## MEMORANDUM

DATE: Tuesday, November 27, 2012  
TO: Amana Construction  
ATTN: Mr. Moses Wazwaz  
PROJECT: 25 Empire Drive, St. Paul, MN  
PROJECT NO.:  
WRITTEN BY: Chris Scheevel

### Background and Description of Structure

Photo 1: Failed Roof Truss

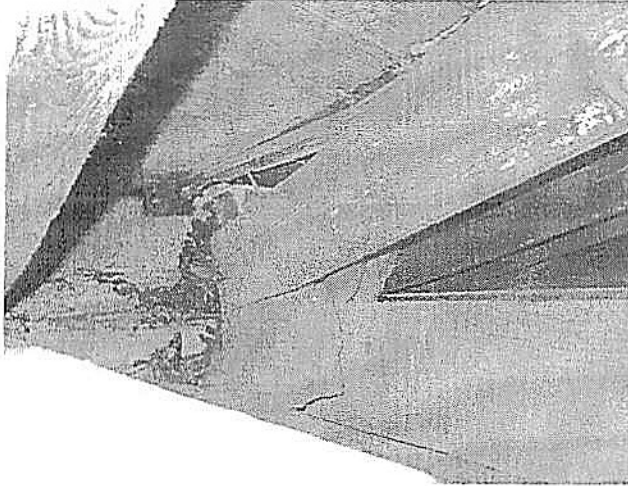
1. Several roof trusses are crushed at their end bearing on the south wall. Water stains indicate water penetration created a suitable environment for decay fungi to attack and weaken the trusses (Photo 1). There is no discernable strength in the trusses at this location. It is our professional opinion that these trusses pose an unsafe condition.
2. The exterior limestone walls are sufficiently bowed to require further analysis to determine the stability of the walls (Photo 2). The walls do not appear to present an unsafe condition but this cannot be verified without further analysis. This analysis is outside the scope of this investigation.
3. One of the steel members in the X-bracing system is buckled, possibly due to movement of the exterior walls.

1. The south ends of the roof trusses require shoring to prevent a sudden collapse. We recommend this shoring be accomplished immediately and before a significant snowfall. Please see the attached sketch for recommended shoring loads and locations..
2. Due to the bowing of the exterior limestone walls, we recommend the walls be analyzed to determine the wall stability under gravity and wind loads.
3. We recommend the X-bracing be analyzed to determine the cause of buckling, and reinforced or replaced, as required.

25 EMPIRE DR SHEDDING PLAN

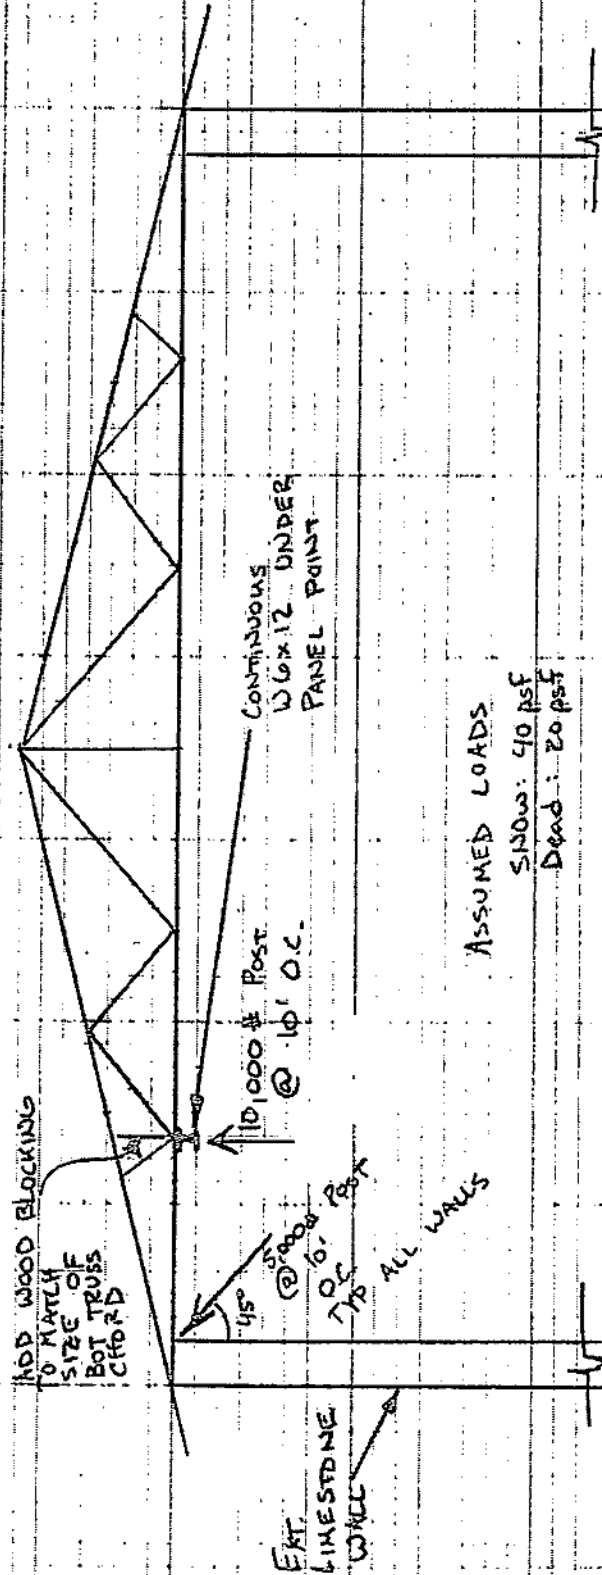
ADD WOOD BLOCKING  
TO MATCH  
SIZE OF  
BOT TRUSS  
CHORD
